# Access Compliance Report

## Public Rights-of-Way

Intersection ID: 53421	Main Street: MATTHEWS_FARM_LN	Cross Street: ARDREY_KELL_RD	Location: SW
ADA ID: F761888349E6	Ramp Type: Perp	Initial Pass/Fail: Fail	Overall Compliance: No
			Severity Score: 13.75

#### Codes/Mitigation Info/Possible Solution

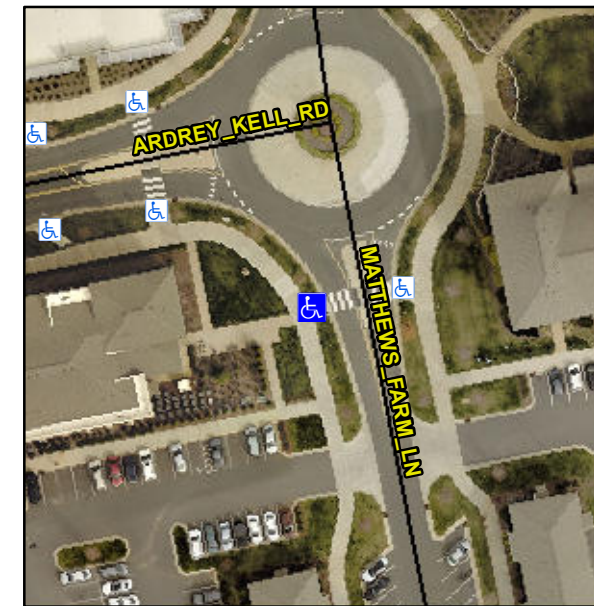
**Not Found, R304.2.2, R304.5.3**

Compliance	Description	Data	Compliance	Description	Data
N/A	Ramp Length (in)	92.0	No	Ramp Slope (%)	8.9
Yes	Ramp Width (in)	119.0	No	Ramp XSlope (%)	2.4
N/A	Flare Type LT	N/A	N/A	Flare Type RT	N/A
N/A	Flare Slope LT (%)	N/A	N/A	Flare Slope RT (%)	N/A
N/A	Flare Traversable LT?	N/A	N/A	Flare Traversable RT?	N/A
N/A	Landing Length (in)	N/A	N/A	DWS Provided?	N/A
N/A	Landing Width (in)	N/A	N/A	DWS Contrast?	N/A
N/A	Landing Slope (%)	N/A	N/A	DWS Length (in)	N/A
N/A	Landing X Slope (%)	N/A	N/A	DWS Full Width?	N/A
N/A	Landing Curb? (Y/N)	N/A	N/A	DWS Offset (in)	N/A
N/A	Shared Landing?	N/A			
N/A	Gutter Ponding?	N/A	N/A	Gutter Slope (%)	N/A
N/A	Gutter Lip Ht (in)	N/A	N/A	Gutter X Slope (%)	N/A
N/A	Painted X Walk1?	Yes	N/A	Painted X Walk2?	N/A
	X Walk 1 Direction	To E		X Walk 2 Direction	N/A
N/A	X Walk 1 Width (in)	121.0	N/A	X Walk 2 Width (in)	N/A
	X Walk 1 Slope (%)	2.7		X Walk 2 Slope (%)	N/A
	X Walk 1 X Slope (%)	2.3		X Walk 2 X Slope (%)	N/A

**Remove & Replace Entire Ramp.**
